Scope Revision Narrative

Austin Police Association Office Building Renovation

Addendum No.: 3

Date: 2026-07-22

AD-201

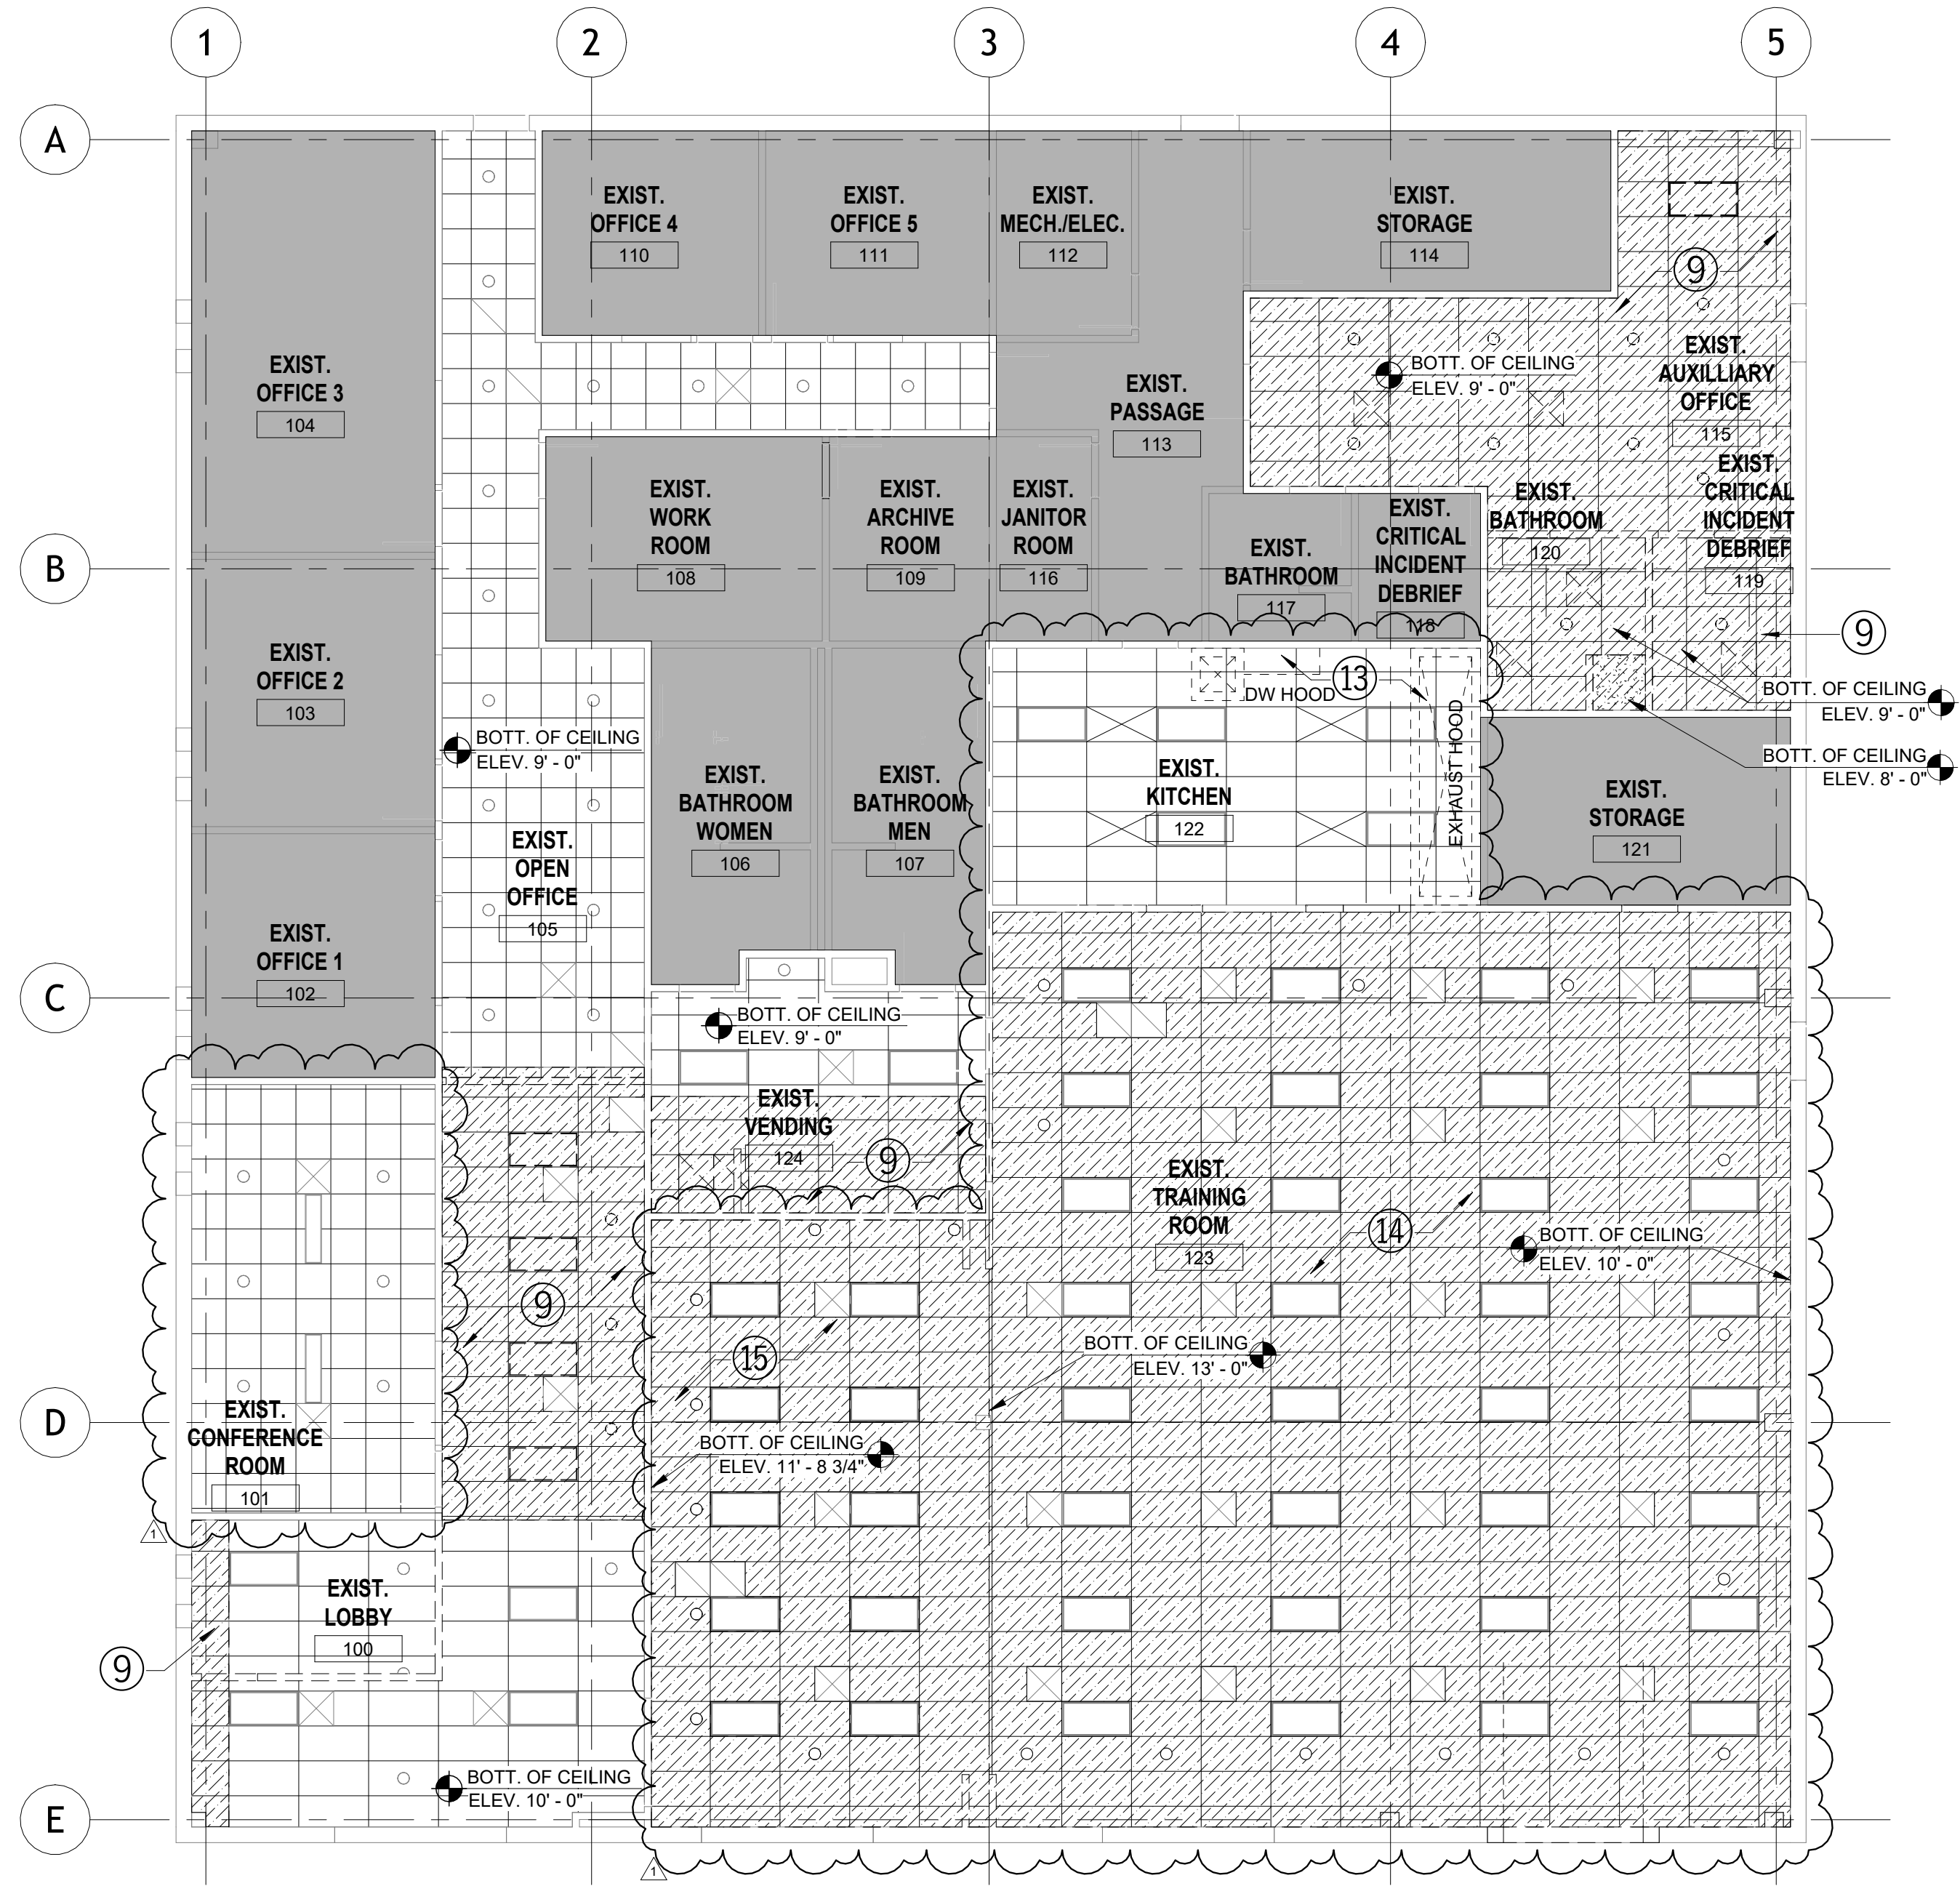
13	AD ALT #2 DEMO KITCHEN EQUIPMENT AND ADD CEILING TILES IN PLACE OF HOOD. ONLY TO PROCEED WITH WRITTEN OWNER APPROVAL
14	REMOVE AND REPLACE CEILING TILES IN THIS AREA. KEEP EXISTING CEILING GRID
15	REMOVE ALL CEILING IN THIS AREA. LIGHTING AND CEILING DIFFUSERS, REGISTERS AND/OR GRILLS TO BE REMOVED AND STORED TO BE REINSTALLED ONCE NEW CEILING IS IN

1. Ceiling work within the Training Hall / Training Room 123 shall be limited to replacement of ceiling tiles only.
2. The existing suspended ceiling grid shall remain.
3. Replacement of the complete ceiling grid is not included.
4. Replacement ceiling tiles shall match the existing size, type, finish, and appearance as closely as reasonably available.

Revise Add Alternate No. 2 to include restoration of the ceiling in areas affected by removal of the existing kitchen hood and associated equipment.
